Petition No. 1770

PETITION NO. 1770 GRAND RIVER LLC C/O GIFFELS WEBSTER 28 W. ADAMS, SUITE 1200 DETROIT, MICHIGAN 48226 C/O MICHAEL MARKS P.E. PHONE NO. 313 980-1469

REQUEST ENCROACHMENT ON GRISWOLD ST. AND W. GRAND RIVER AVE. (For Various Architechtural Elements)

CITY OF DETROIT CITY ENGINEERING DEPARTMENT						
SURVEY BUREAU						
JOB NO.	01-01					
DRWG. NO.	X 1770

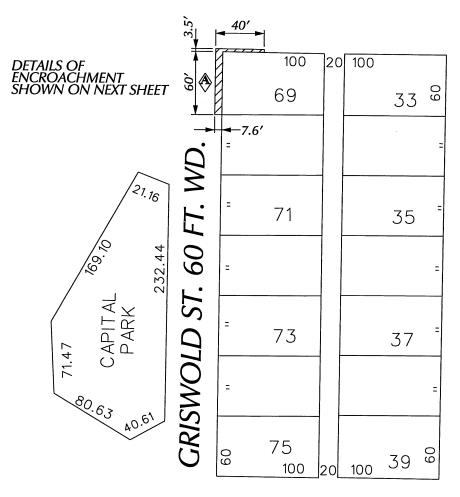
- () Not Involved.
- () Involved; but asking you to hold action on this petition until further notice.
- () Involved; the nature of our services, and the estimated costs of removing and/or rerouting such services are:
- (X) Involved; have no objection to requested encroachment on Griswold St. and W. Grand River Ave. (For Various Architectural Elements) as shown on drawing no. x1770 dated 02/06/2018 and on proposed plans attached herewith, provided that;
 - (1) The encroachment shall be completely cantilevered and shall not have any support on the grade level.

(2) A minimum of 8ft. clear height/under clearance shall be maintained at the ground level.
